PROPOSAL

RECOMMENDATION

1200 Longfellow Proposed Two-Stories, Two-Car Detached Garage

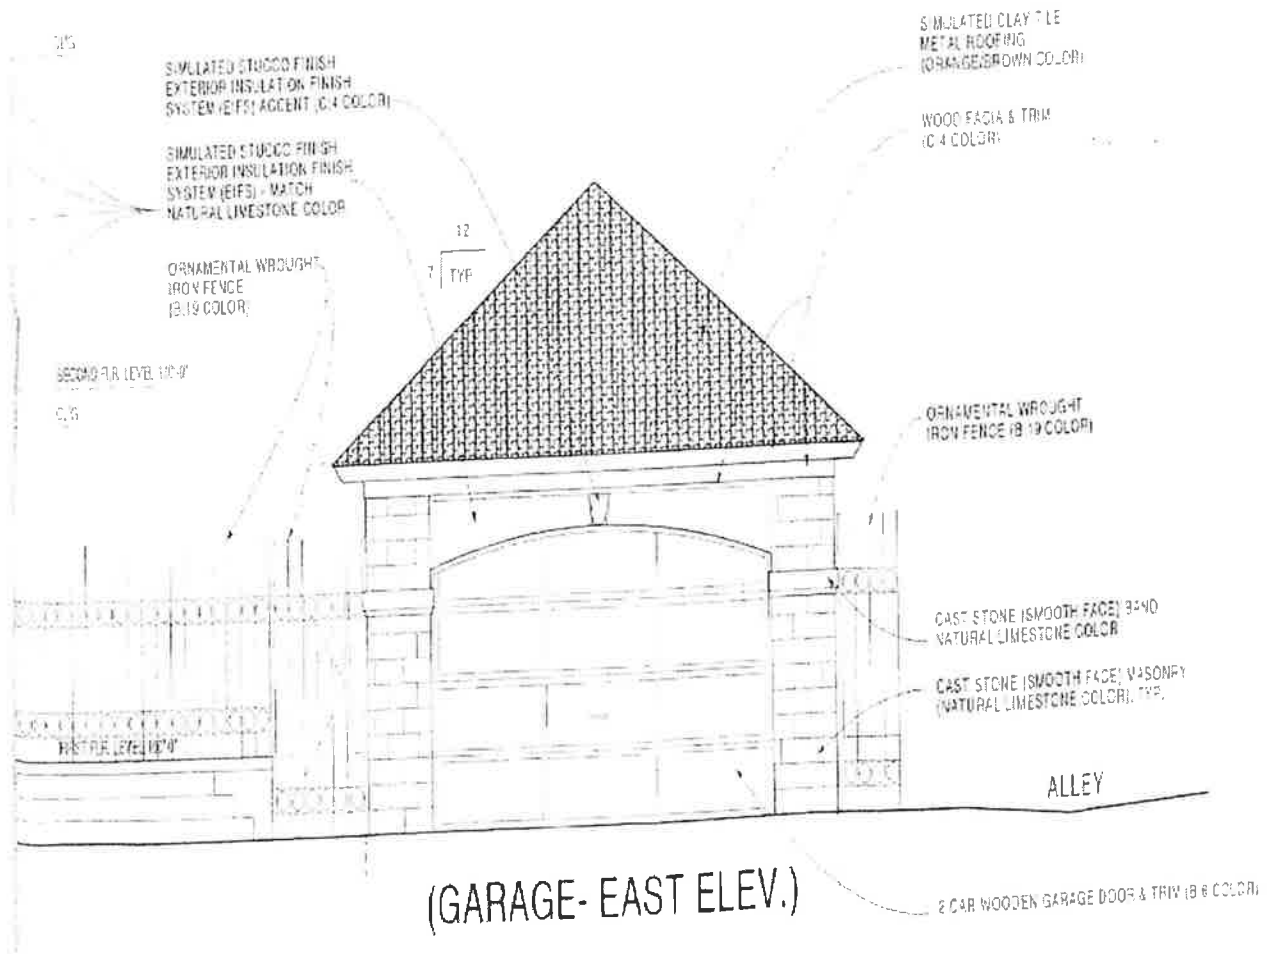
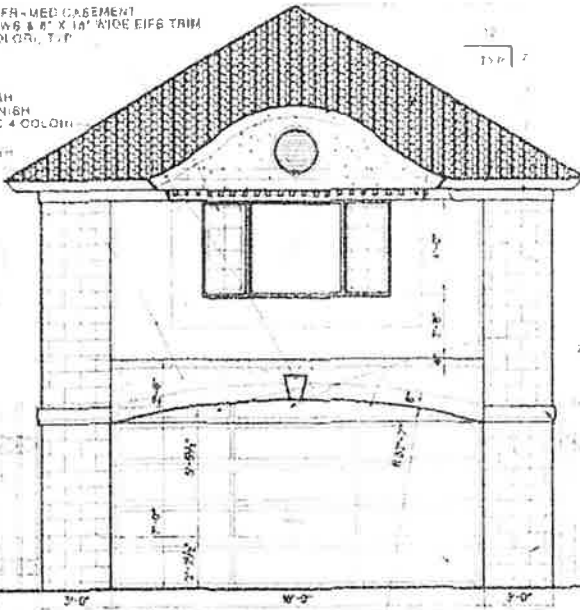
The applicant received a Certificate of Appropriateness June 12, 2008 for the construction of an 1840 sq. ft. single family home, 836 sq. ft. two-car detached garage, and the addition of landscaping on the vacant lot located at the corner of Longfellow Avenue and the John C. Lodge Service Drive. The applicant is proposing to increase the height of the garage from one-story to two-stories. The approved paint colors, materials, and footprints for the garage and house will remain the same as noted on the site plan and elevations approved by the HDC on June 12, 2008.

Staff recommends the Commission issue a Certificate of Appropriateness to increase the garage height from one-story to two-stories, keeping the same colors, materials, and footprint that was approved by the Commission in the Certificate of Appropriateness issued on June 12, 2008. These changes meet the Secretary of the Interior's Standards for Rehabilitation standard number 9: New additions, exterior alterations, or related new construction shall not destroy historic materials that characterize the property. The new work shall be differentiated from the old and shall be compatible with the massing, size, scale, and architectural features to protect the historic integrity of the property and its environment."
